SUBJECT: SURRY POWER STATION, UNIT 1 - AMERICAN SOCIETY OF MECHANICAL ENGINEERS BOILER AND PRESSURE VESSEL CODE, SECTION XI, RELIEF REQUEST PRT-01 (TAC NO. MC1830)

SAFETY EVALUATION BY THE OFFICE OF NUCLEAR REACTOR REGULATION

RELIEF REQUEST PRT-01

SURRY POWER STATION, UNIT 1

Figure 1 Cross-sectional view of head-to-flange weld showing the required inspection volume (within dashed lines) and UT beam. The figure illustrates that inspection from the flange side is severely limited due to transition angle and location of weld.

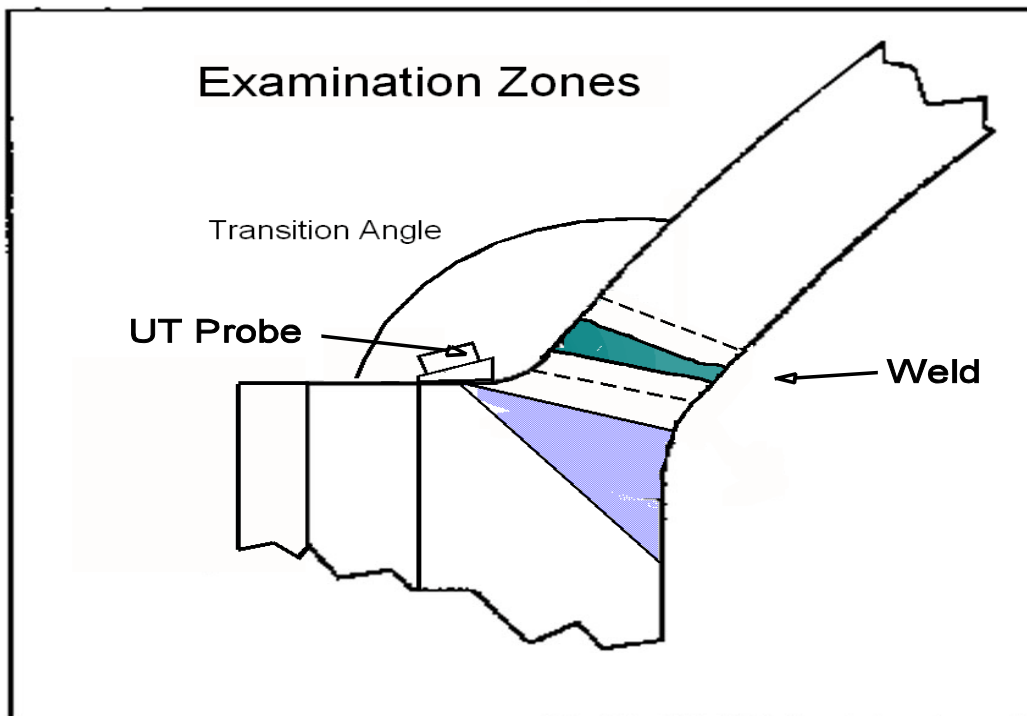
The cross-sectional geometry of the RPV head-to-flange weld produces a high transition angle between the flange and the domed head. As illustrated in Figure 1, scanning from the flange side of the weld is severely limited due to location of the weld and the transition angle. In addition, the location of three closure head lifting lugs further restricts access for performing ultrasonic examination of this weld. For these reasons, the component configuration does not allow the licensee to obtain the full ASME Code-required volumetric coverage from both sides of the weld. For the licensee to achieve 100-percent volumetric coverage, the RPV closure head would have to be redesigned and modified. This would place a significant burden on the licensee, thus the ASME Code-required 100-percent volumetric examination is impractical for the head-to-flange weld.

By letter dated January 22, 2004, the licensee provided information showing that a substantial amount (approximately 66 percent) of the ASME Code-required examination volume can be

obtained with the perpendicular, parallel and 0-degree angle ultrasonic scans that were performed from the head side of the weld. For both the 45- and 60-degree angle scans, the licensee was able to achieve the ASME Code-required coverage from a single side. In addition to the volumetric examinations of this weld, the licensee was able to obtain essentially 100 percent of the ASME Code-required surface examinations performed on the outside of the component. The examinations completed by the licensee establish a reasonable basis for comparison with future inservice examinations and should have detected any significant conditions that might challenge the structural integrity of the subject welds. Therefore, the licensee's proposed alternative provides reasonable assurance of structural integrity of the subject component.

The NRC staff concludes that for RR PRT-01, the required Code examination coverage is impractical to perform on the subject RPV head-to-flange weld. Furthermore, the NRC staff concludes that the coverage obtained from ultrasonic and surface examinations provides reasonable assurance of structural integrity of the subject component. Therefore, RR PRT-01 is granted pursuant to 10 CFR 50.55a(g)(6)(i) for the third 10-year ISI interval for SPS-1. The NRC staff notes that this approval is only applicable to the preservice examination requirements.
